**SERVICE
BULLETIN
413
4 CYCLE**

SUBJECT: 120-Volt Starter Stays Engaged

STARTER MODEL NUMBER: 37000

DATE CODE: 0104 through 0196 (Fig. A)

Fig. B

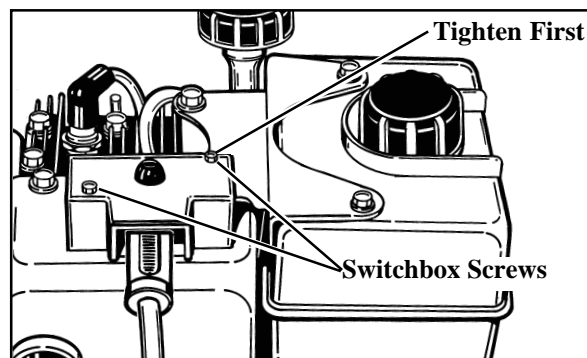
During the evaluation we found the installation sequence of the switch box mounting screws to be critical for proper operation. In most cases, loosening the two mounting screws, then reinstalling them in the correct sequence and to the proper torque, corrects the problem.

1. Verify the condition of the switch by attempting to start the unit with the starter.
2. If the condition exists, loosen the switch box screws as shown in Fig. B.
3. Next re-install the screws. **YOU MUST** tighten the screw closest to the fuel tank first and torque it to no more than 18-INCH LBS; then torque the second screw to the same value.
4. Re-test the starter operation by intentionally pushing the starter button sideways at 90-degree intervals as shown in Fig. C. If no sticking occurs, the customer is ready to use the machine.
5. Should the problem still exist, the starter must be replaced by ordering part number 33329E from your normal source of supply.
6. When the repair is complete, file a standard ESA 157 warranty claim form for the repair. If the starter was replaced, please return the defective starter with your claim. This repair typically takes 15 minutes.
